**DATE:** 05.29.2018

■ **CENTERPOINT [Subdivision Plan Review #3]**

**TECHNICAL STANDARDS – NEW ROADS:**

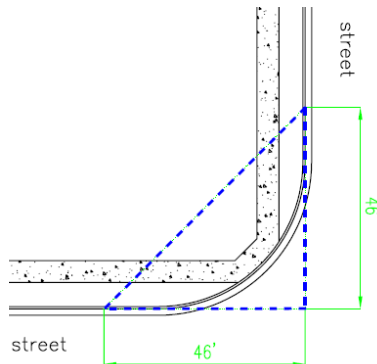
3. The sight distance triangle at each street corner intersections with Eastwood Rd and Military Cutoff Rd is not implemented as per below image. Show and apply the City's 46'x46' sight distance triangle at each street corner intersection on the site plan and landscaping plan. [\[Sec.18-529\(c\)\(3\)CofW LDC\]](#) Add a note indicating that all proposed vegetation within sight triangles shall not interfere with clear visual sight lines from 30"-10'. [\[Sec.18-556 CofW LDC\]](#).
